CONNECTION ASSESSMENT & APPROVAL PROCESS

PRELIMINARY ASSESSMENT REPORT

*For the Proposed 115kV Supply to the North Caribou Lake
First Nation Community*

CAA ID No. 2001-044

DIAGRAM 4

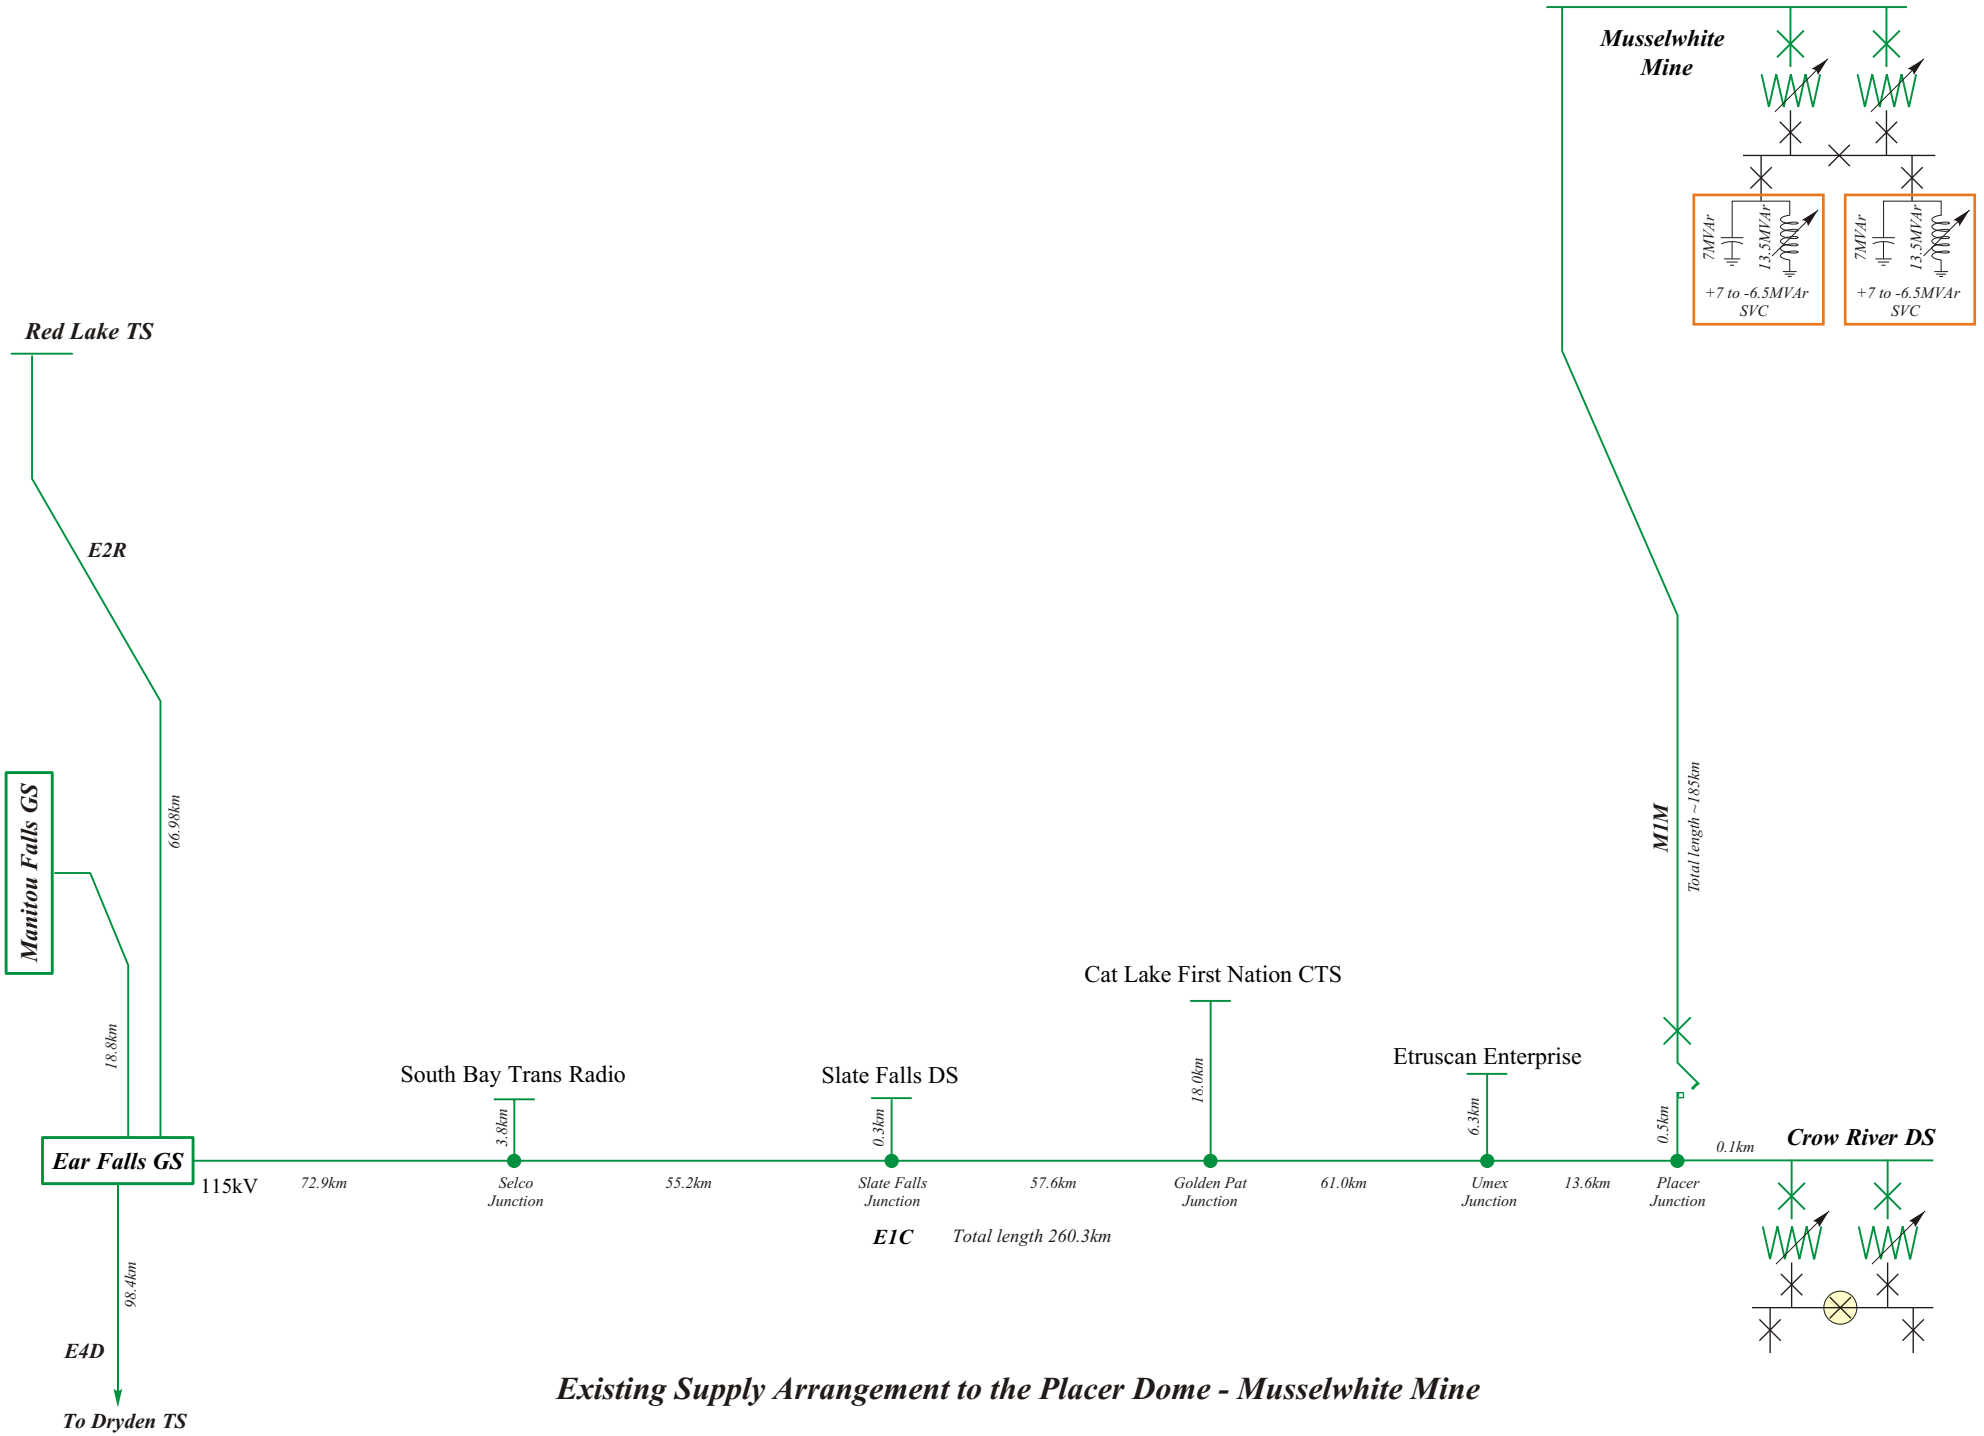
- Install a 115kV shunt reactor, rated at between -2MVar & -2.5MVar (at 118kV), connected directly to circuit M1M via a 115kV circuit-switcher, at the connection point on to circuit M1M (NCLFN Junction).
- Install a +6MVar/-11MVar SVC at Crow River DS.
[It is expected that two shunt capacitor banks, each rated at approximately +3MVar, will need to be installed to provide filters for 5th & 7th harmonic currents.]
- Install a scheme for the automatic post-contingency reinsertion (into service) of the -2MVar shunt reactor at the NCLFN Junction for a contingency involving the NCLFN line. This scheme is to include the capability to remotely select (pre-arm) this auto-switching operation.

All facilities associated with the NCLFN line must be suitable for continuous operation at 138kV.

Diagram 4 shows the facilities required for the connection of the NCLFN line.

DIAGRAM 3

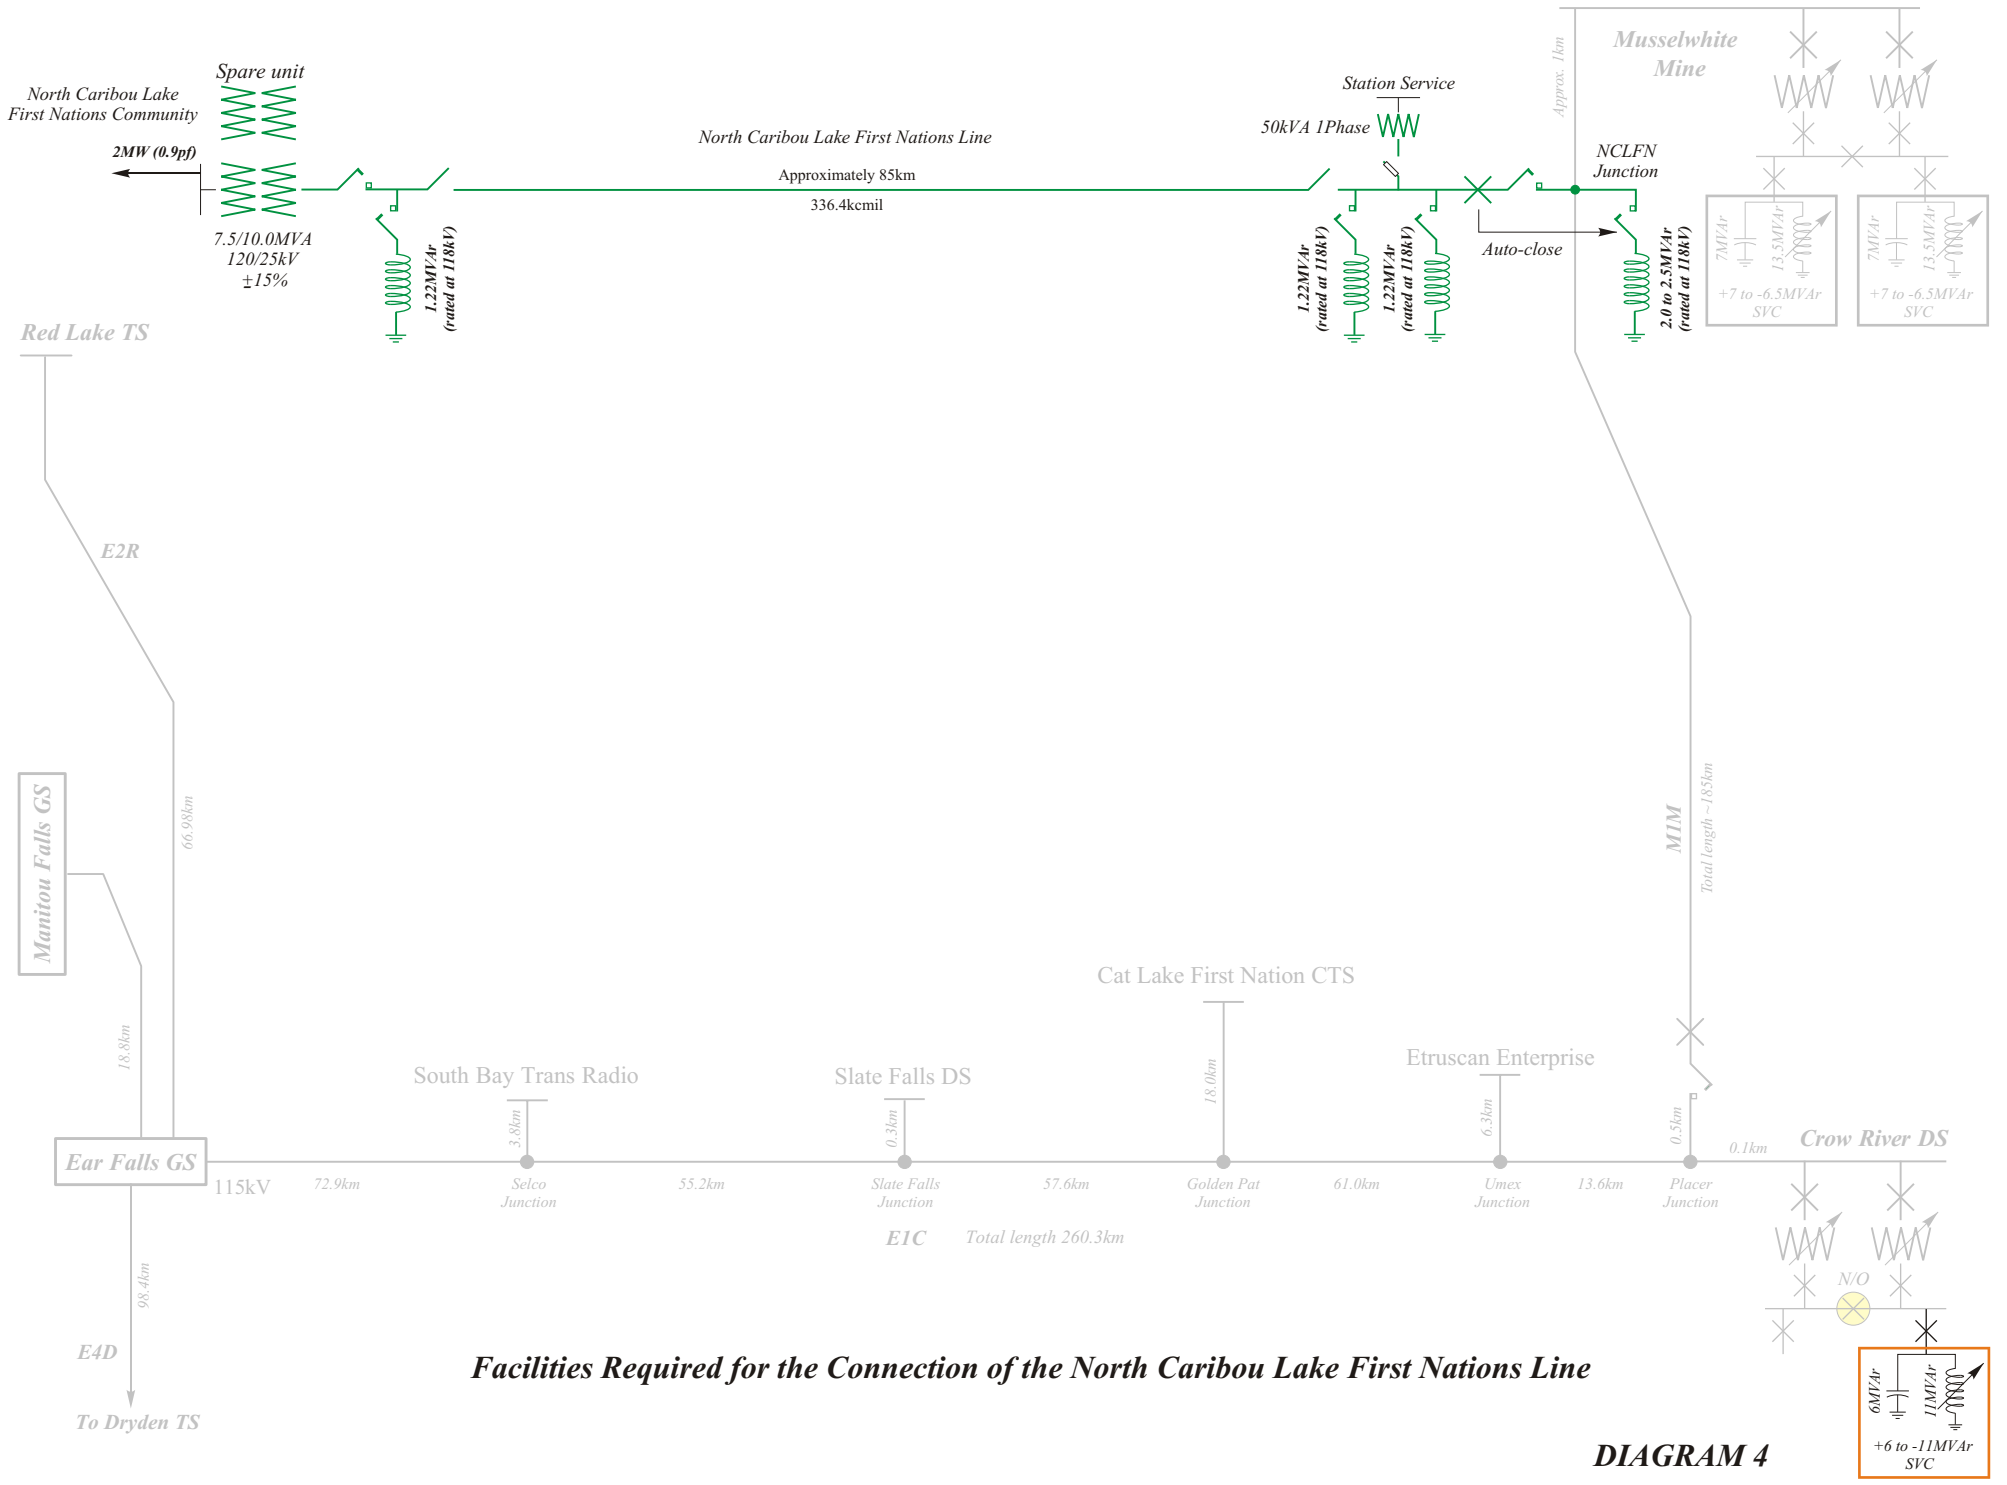
Diagram 3 shows the proposed arrangement with a new SVC installed at Crow River DS, together with a -2MVAR shunt reactor at the NCLFN Junction.

Studies were therefore performed for the arrangement shown in Diagram 3 with the load at the Musselwhite Mine at assumed power factors of 0.90 and 0.94, respectively.
